## PLANNING AND DEVELOPMENT SERVICES STAFF REPORT

For Planning Commission Meeting of June 16, 2009

**SUBJECT: Near North PUD Zoning District and PUD Site Plan  
(626-724 North Main Street) File No. SP08-023**

•  
**Before**

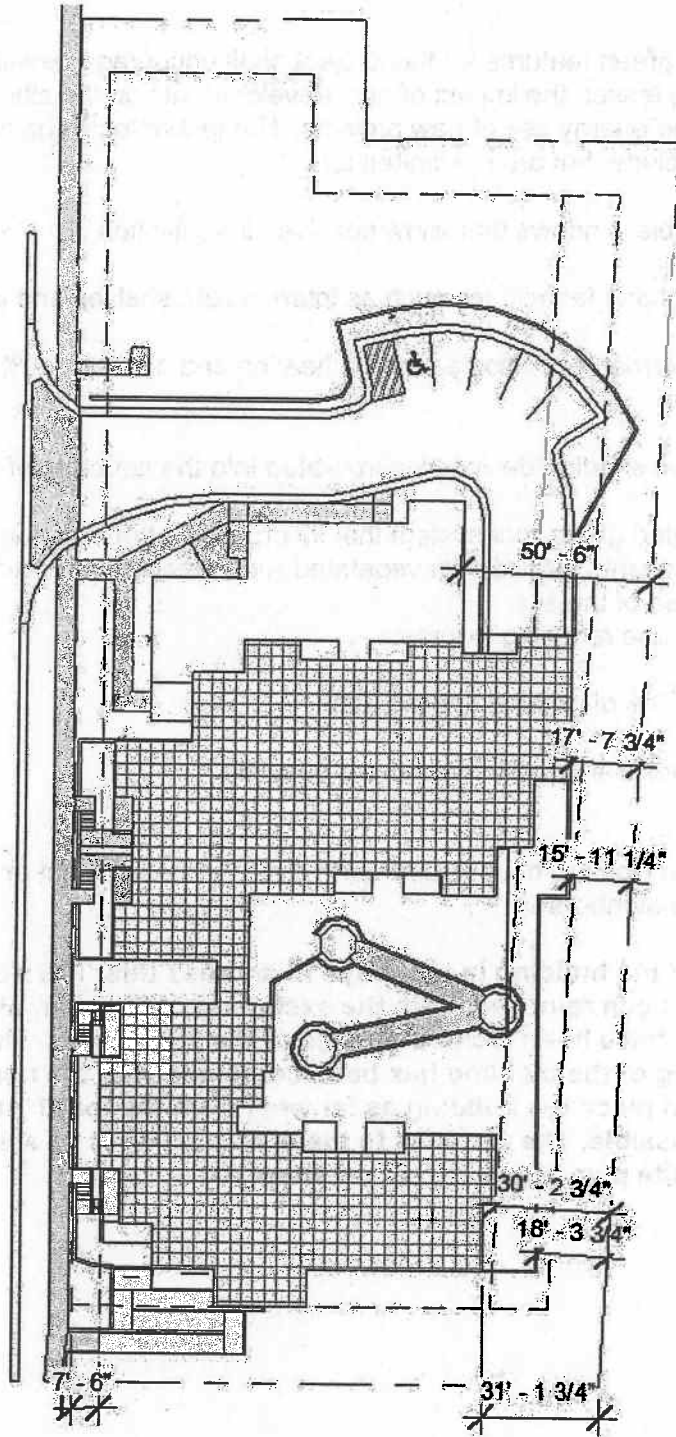
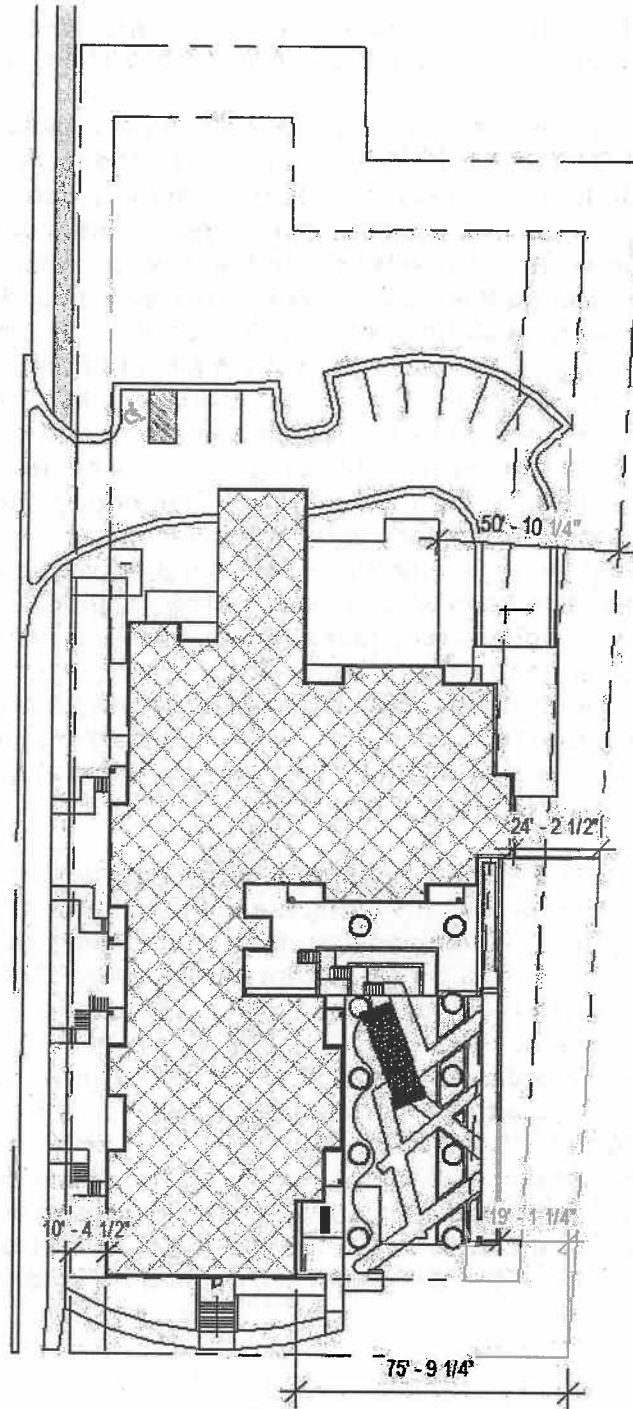
- i. Operable windows that allow passive air ventilation.
  - ii. Day lighting techniques such as internal light shelves and large windows.
  - iii. Geothermal technologies for the heating and cooling 100% of the building.
  - iv. Passive shading devices incorporated into the structure of the building.
  - v. A planted green roof system that incorporates the necessary detention for storm events, providing a vegetated roof surface that covers over 50% of the area of the site.
  - vi. Water use reducing fixtures
  - vii. Over 70% of parking underground.
  - viii. Pervious Parking Surface where possible.
5. Rear setbacks are too close to houses on Fourth Ave. Address height and privacy impacts on adjacent neighbors.

**We have revised the building in two ways to address this. The North East corner has been removed. With the exception of the stair, all residential units have been located outside of the 30' setback. The entire south wing of the building has been combined with the north-south corridor to place the building as far west from the fourth street neighbors as possible. The distance to the property line is as shown within the new site plan submittal set on sheet A-1.**
